CHARLOTTE HISTORIC DISTRICT COMMISSION
CERTIFICATE OF APPROPRIATENESS - AMENDED

CERTIFICATE NUMBER: HDCADMRM-2017-00063

ADDRESS OF PROPERTY: 1818 Euclid Av

Office
Renovation
Project
1818 Euclid Ave.
Charlotte, NC
for
Taylor &
Merideth Croy

Site Plan - March 2017

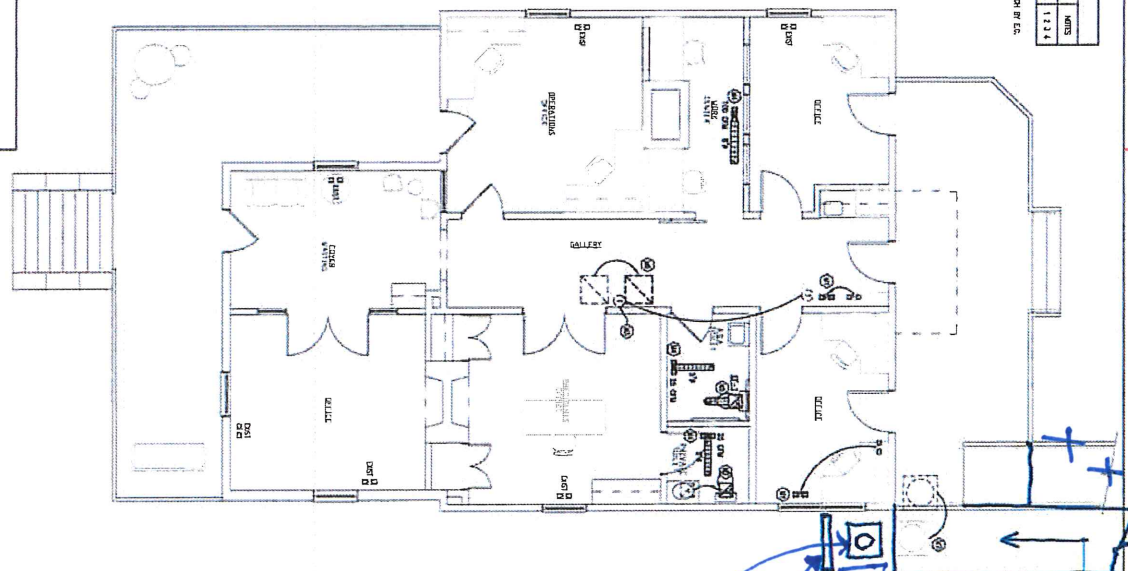
2. Front Walkway. A brick walkway will be installed between the building's existing front steps and the public sidewalk.
3. Rear Addition. A new deck and handicap access ramp will be added to the rear of the house. The deck measures approximately 10'-0" x 26'-9" see attached exhibits labeled 'Site Plan – March 2017' and 'Deck & Ramp Design – March 2017'. The deck, ramp, and rails will all be wood. For the handrail, the vertical pickets will be centered on the top and bottom horizontal rails and an additional piece of trim will be added on the top rail. To accommodate the deck/ramp addition the existing HVAC will be replaced and relocated to the right side. The HVAC unit will be screened with evergreen bushes and/or a small fence that obscures the unit from both street view and from neighboring property to the right. If a small fence is used, then the design must be approved by HDC staff prior to installation.

Rear Doors - March 2017

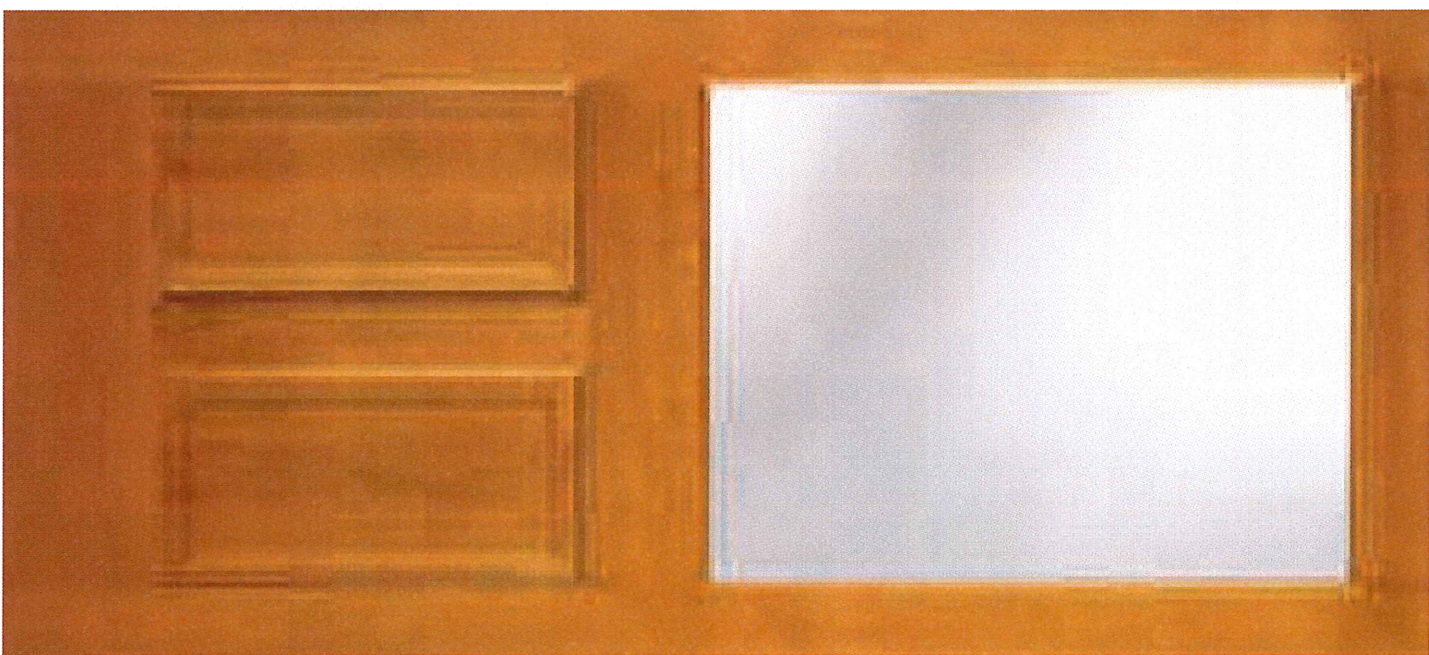
4. Rear Entry Doors. The three non-original rear entry doors will be replaced, see attached exhibit labeled 'Rear Doors – March 2017.'
5. Crawl Space Door. A new wood crawl space door located along the left elevation will be replaced. The existing door is a replacement piece of plywood. The new wood door will be custom built to fit the opening.
